CITY OF TULSA
PUBLIC WORKS
Engineering

ADDENDUM NO. 4

ADDENDUM NO. 4
TO
PROJECT NO. 2036W0001Z, 2036A0024Z & TMUA-W 22-37
ARTERIAL STREET RECONSTRUCTION GILCREASE MUSEUM RD. (N. 25th W. AVE.) W. ADMIRAL BLVD. TO W. PINE ST.

ADDENDUM NO. 4
TO
GILCREASE MUSEUM RD.
(N. 25TH W. AVE.)
W. ADMIRAL BLVD TO W. PINE ST.
PROJECT NOS. 2036W001Z, 2036 A0024Z & TMUA-W 22-37

NOTES:

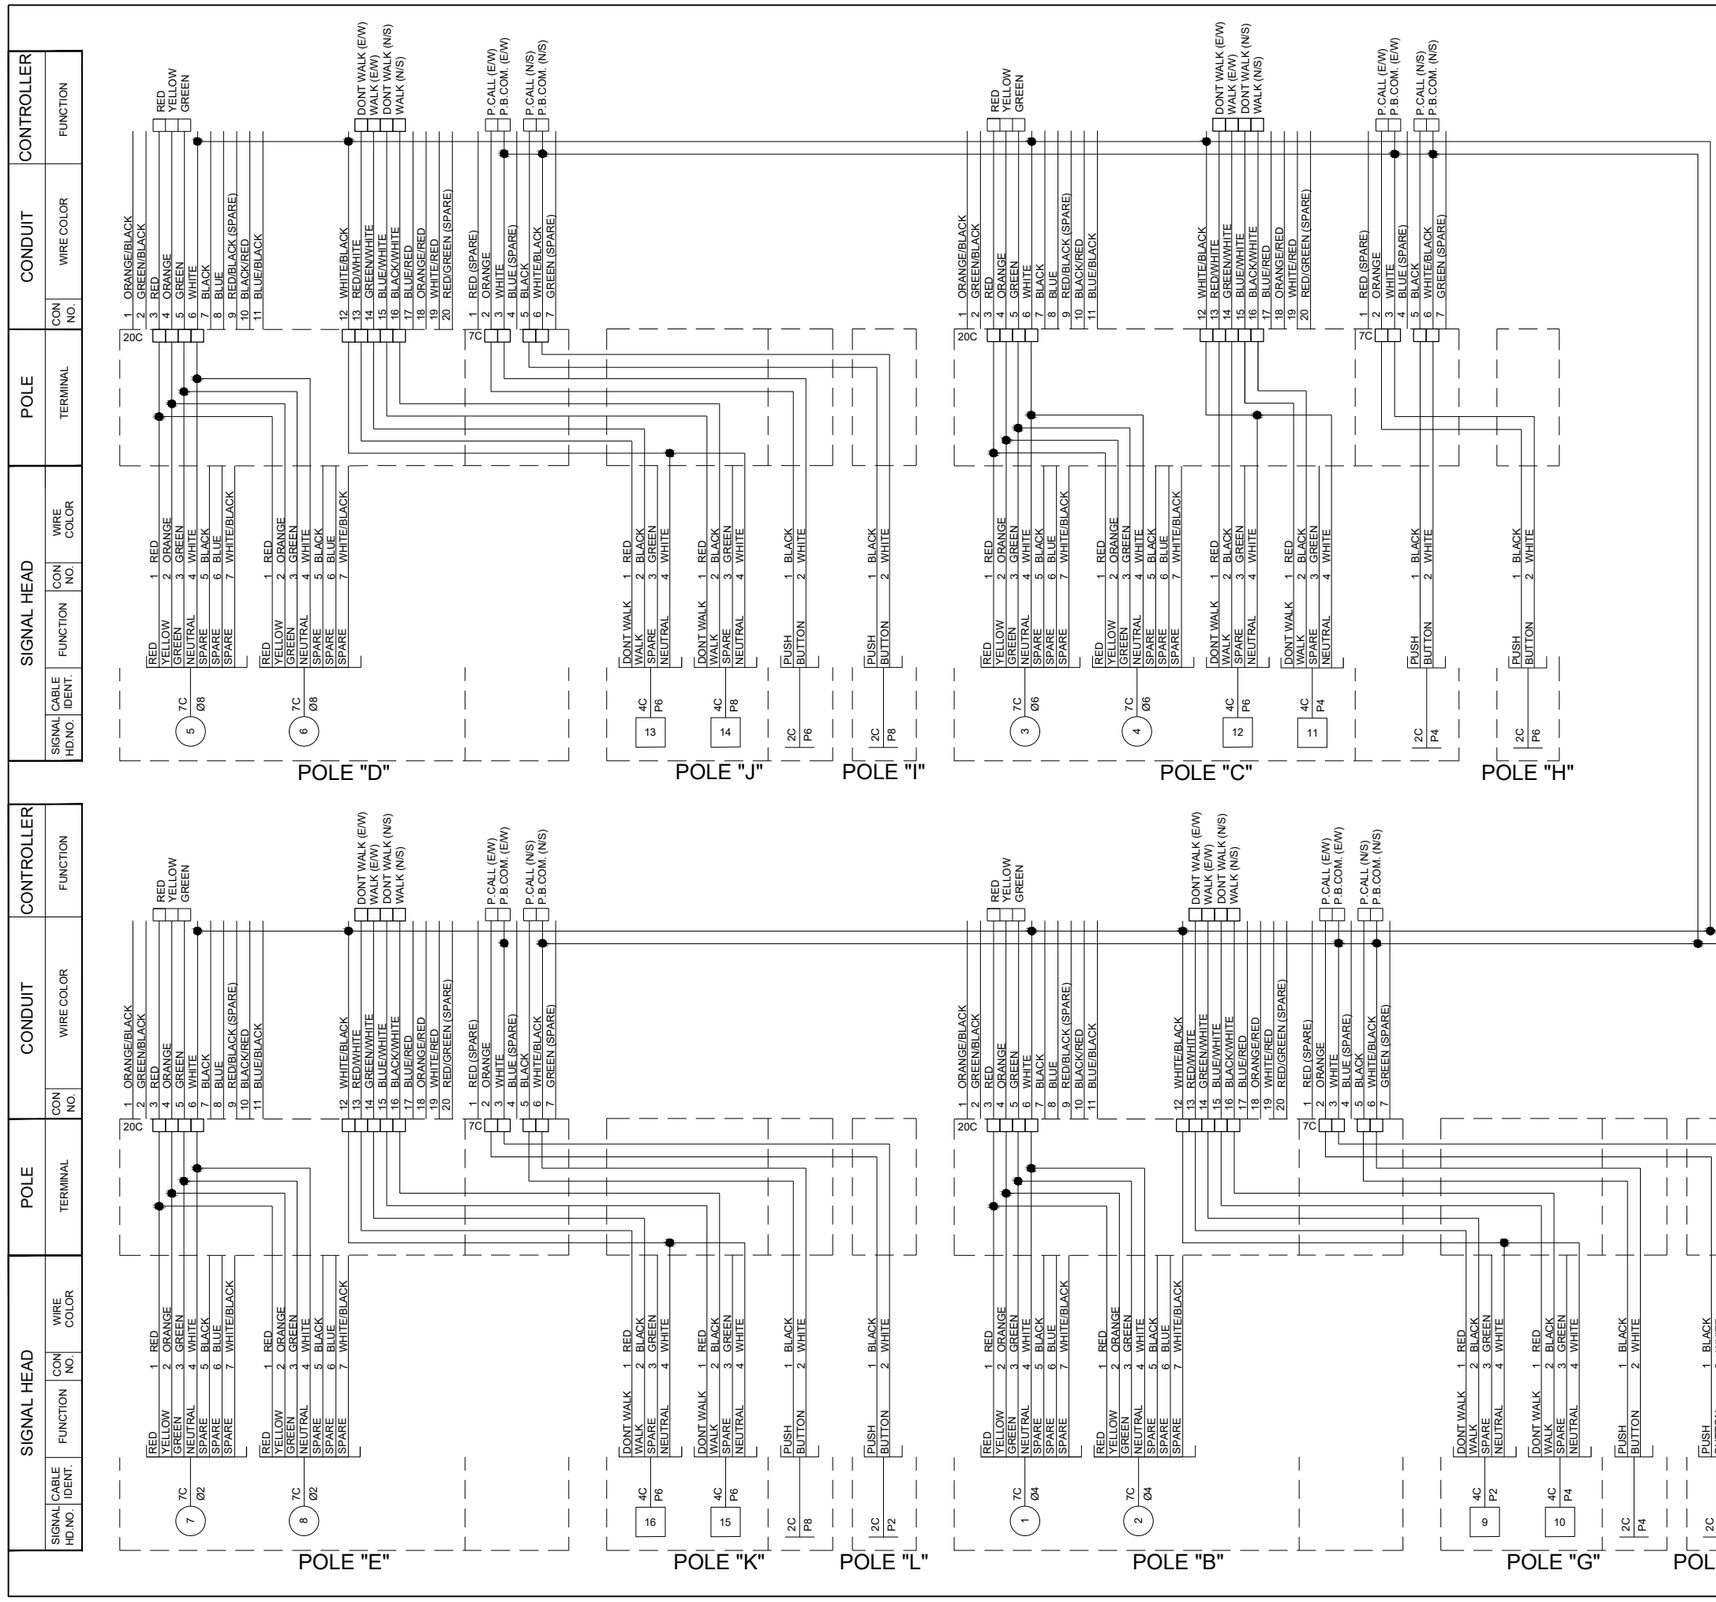
- Added non-pay quantities of concrete and steel used in decorative wall pay item.
- No. S52 with revised Details and Notes.
- Nos. 81 to 86 with revised Signal Designs and Phasing Diagrams.

LIGHTING INSTALLATION PLAN (SHEET 1 OF 2)

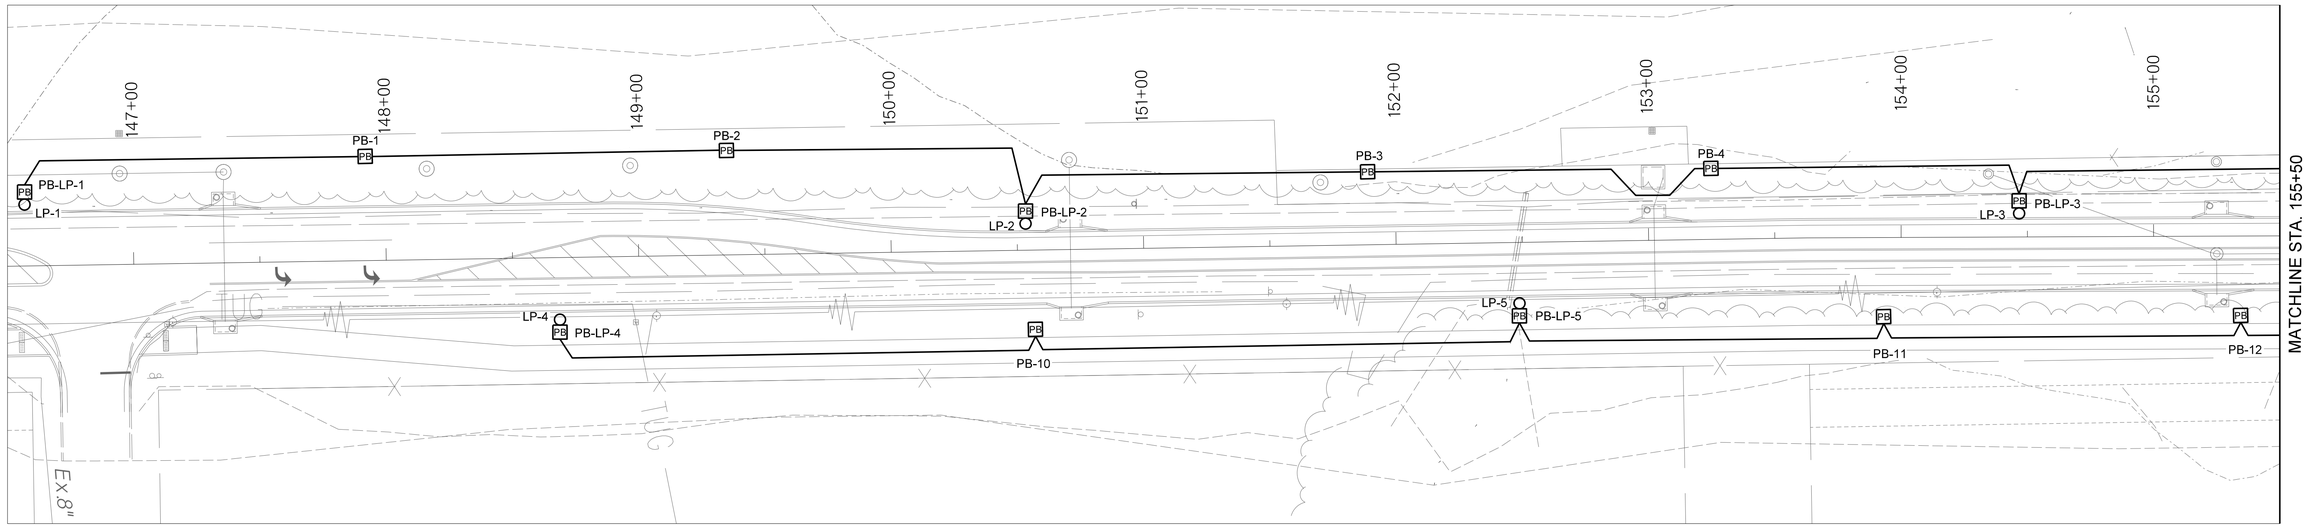
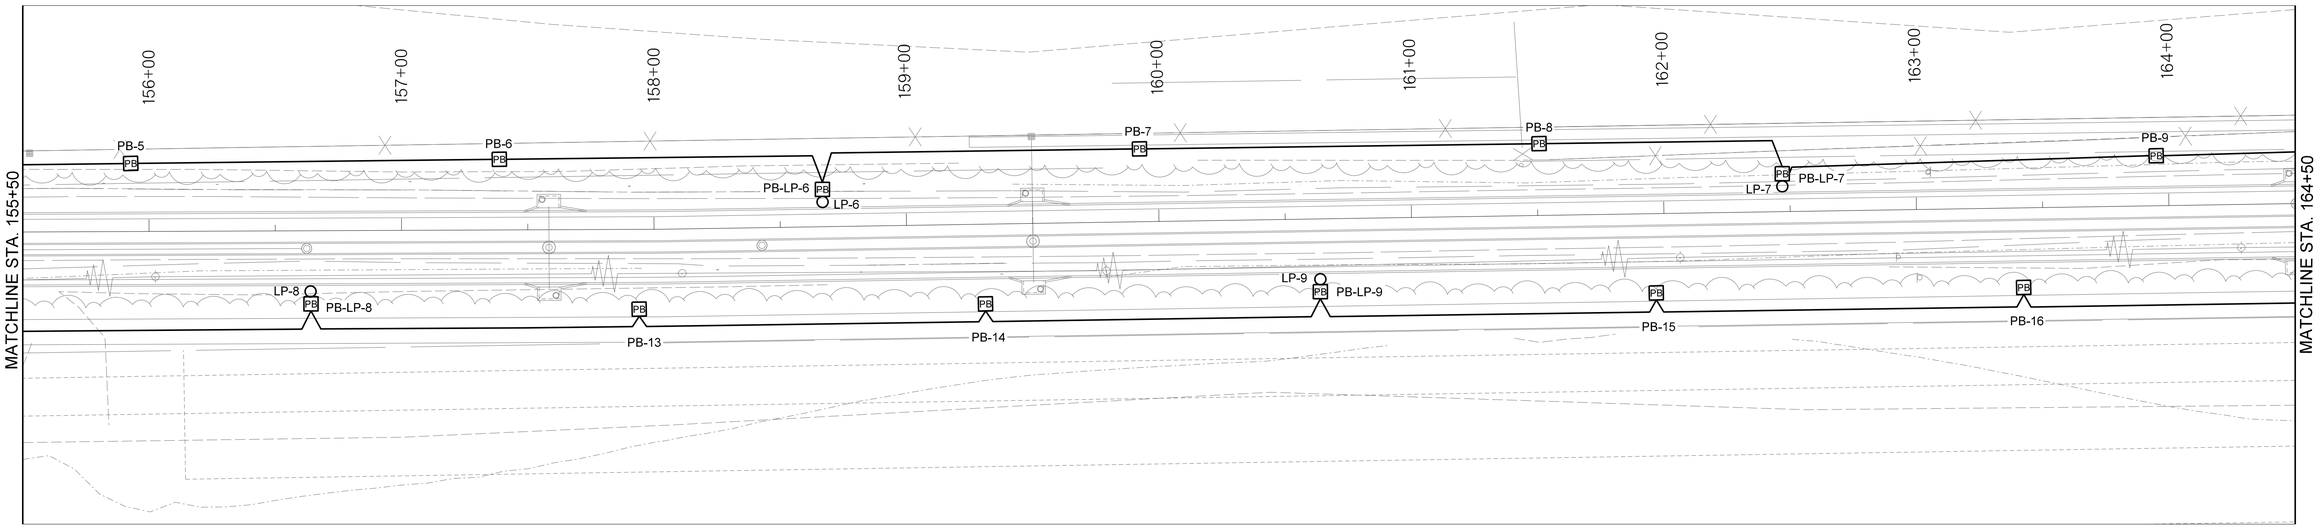
- No. 115B “LIGHTING INSTALLATION PLAN (SHEET 1 OF 2)
  - Updated design previously detailed on previous sheet No. 115 with new conduit routing, pull box locations, and staking locations for coordinating installation of light poles by others.

LIGHTING INSTALLATION PLAN (SHEET 2 OF 2)

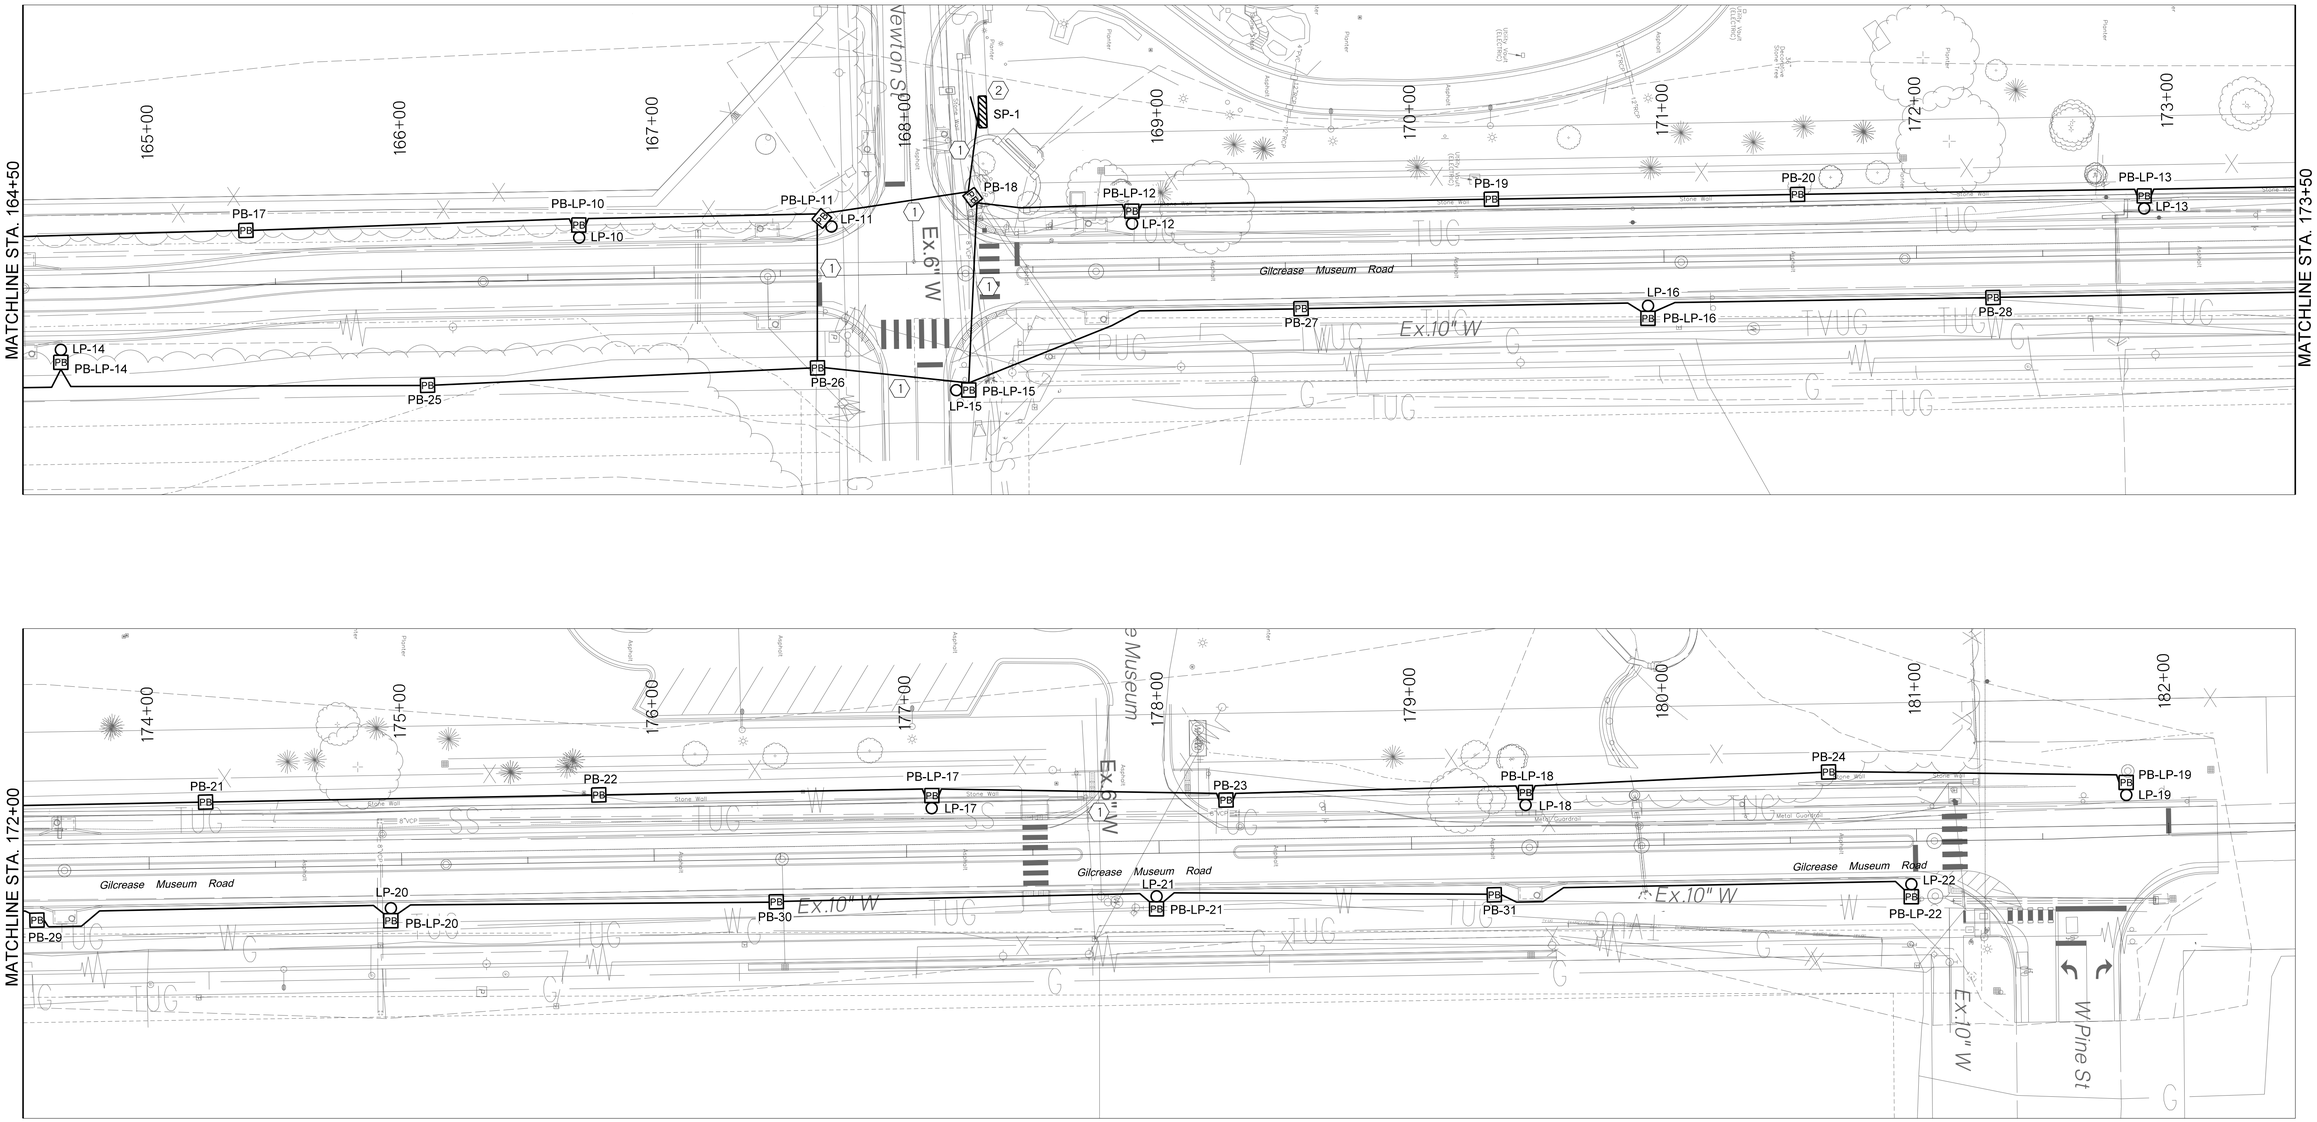
- No. 116 with revised plan sheet No. 116
    - Updated title from "LIGHTING INSTALLATION PLAN 2" to "LIGHTING INSTALLATION PLAN (SHEET 2 OF 2)".
    - Updated design with new conduit routing, pull box locations, and staking locations for coordinating installation of light poles by others.

LIGHTING DETAILS (SHEET 1 OF 2)

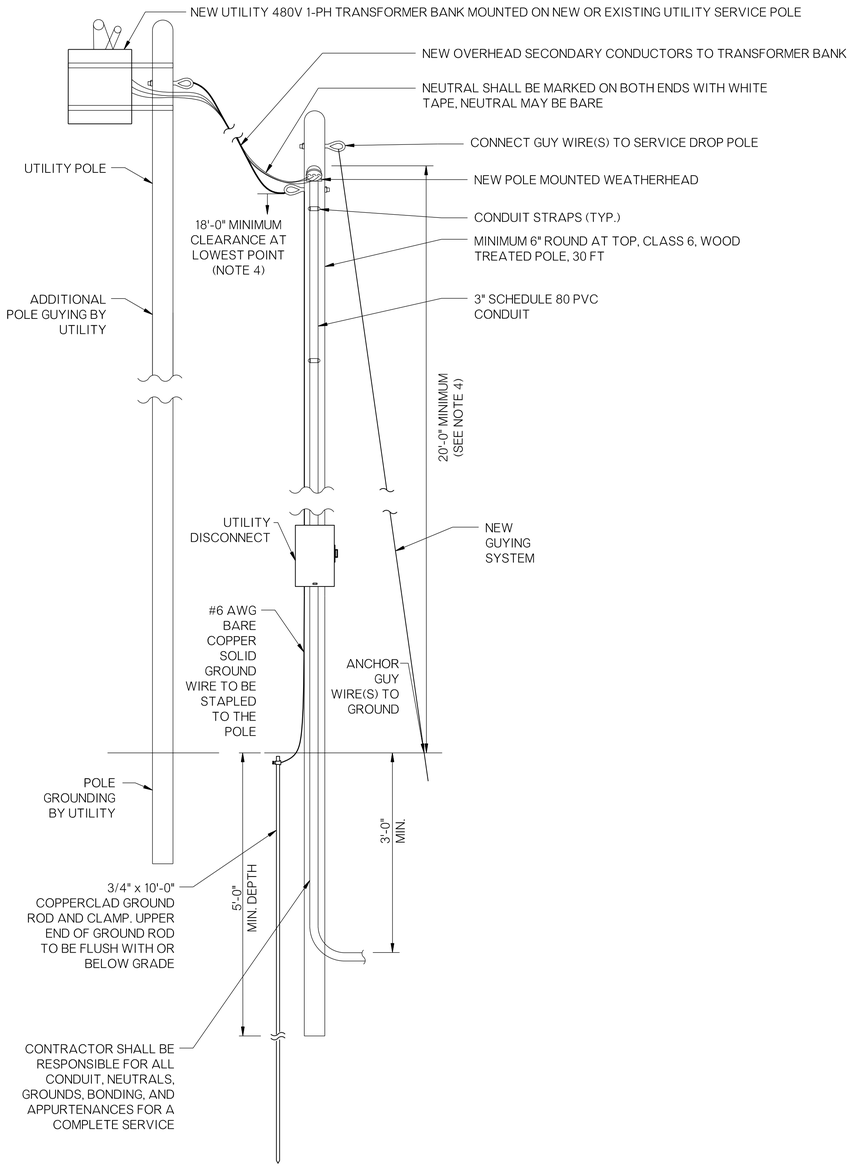
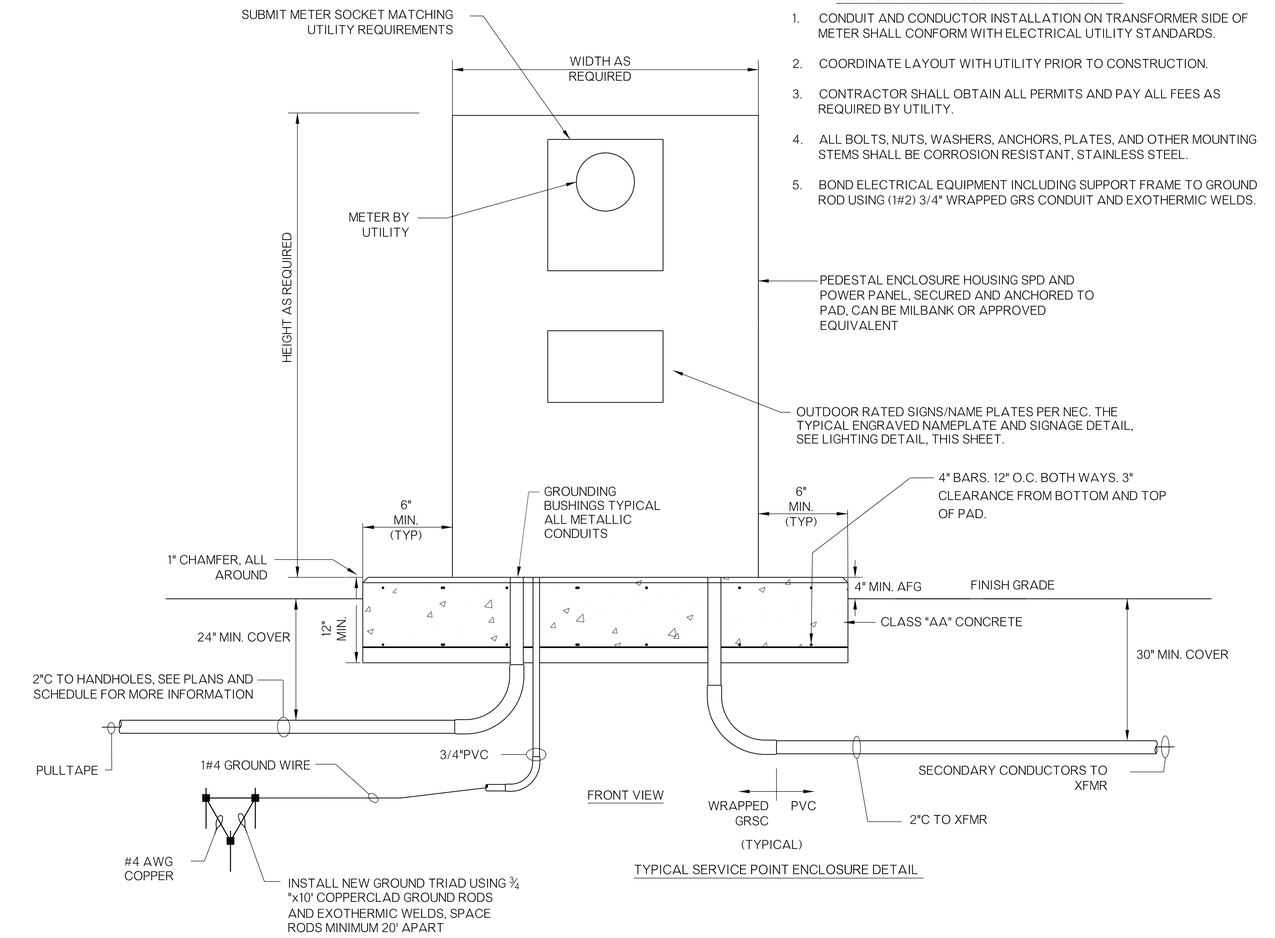
- Updated lighting legend with updates to light pole and handhole detailed on updated sheet No. 115.
- NO. 116A “LIGHTING DETAILS (SHEET 1 OF 2)
  - Added details for the service installation, underground warning tape, and the service point enclosure.
